#### DOMINION ENERGY KEWAUNEE, INC. KEWAUNEE POWER STATION INSERVICE INSPECTION PROGRAM FOURTH TEN-YEAR INTERVAL LIMITATION TO EXAMINATION RELIEF REQUEST NO. RR-G-5

# **RELIEF REQUEST NO. RR-G-5 (SERIES SUMMARY)**

## Kewaunee Power Station Fourth Ten-Year Interval Inservice Inspection Program Relief Request No. RR-G-5 (Series Summary)

Figure 1 RV-W7

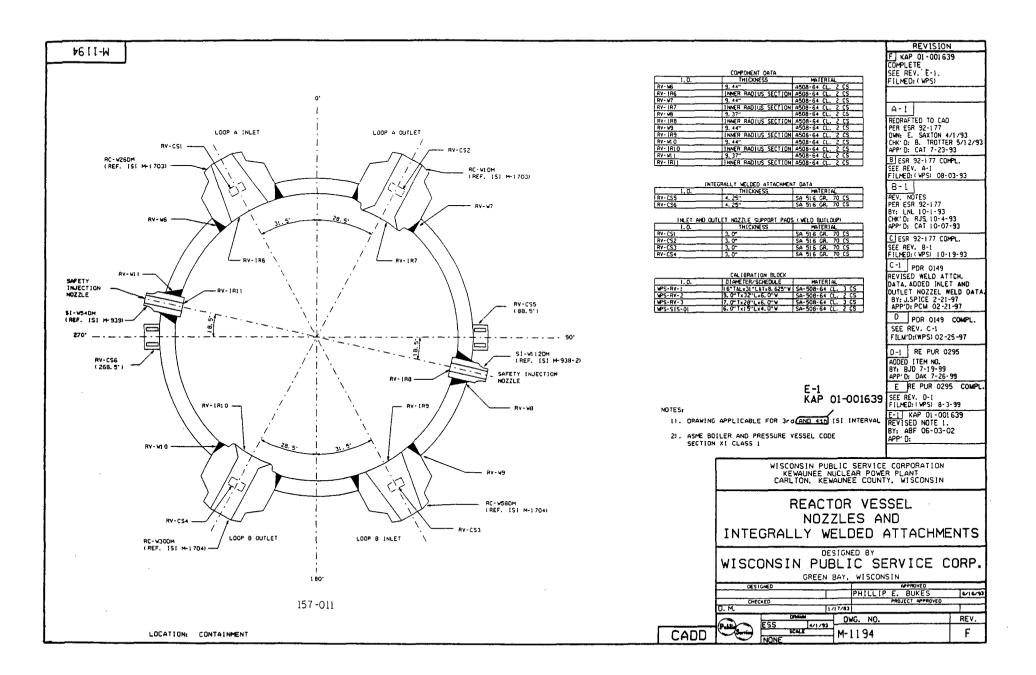
# Limitation: Nozzle protrusion and vessel saddle geometry

Figure 1 RV-W10

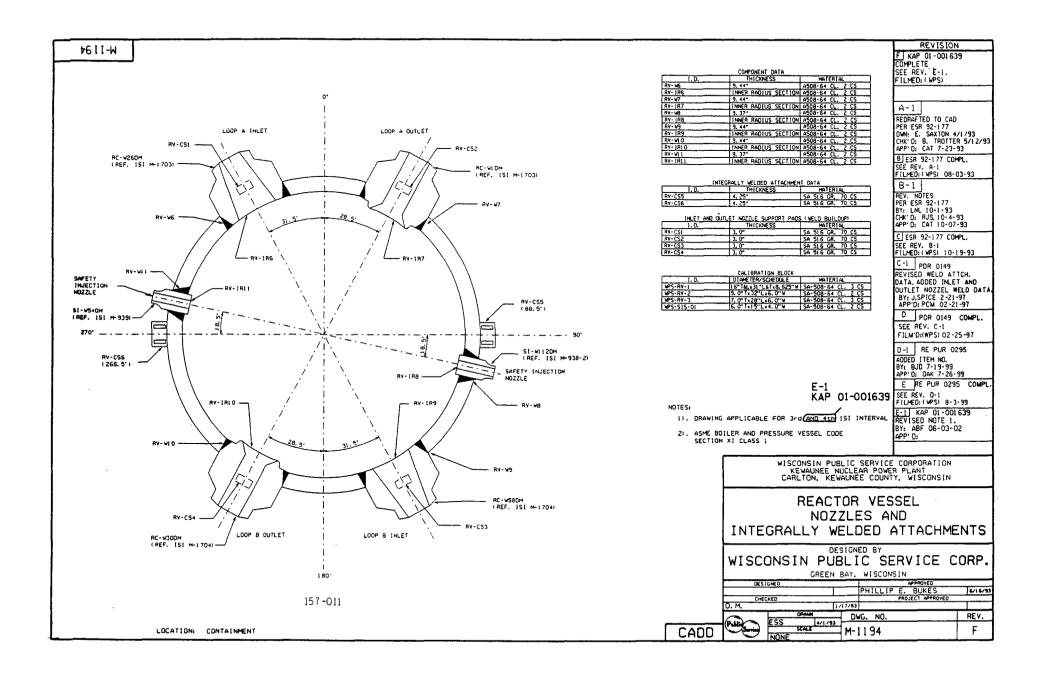
Limitation: Nozzle protrusion and vessel saddle geometry
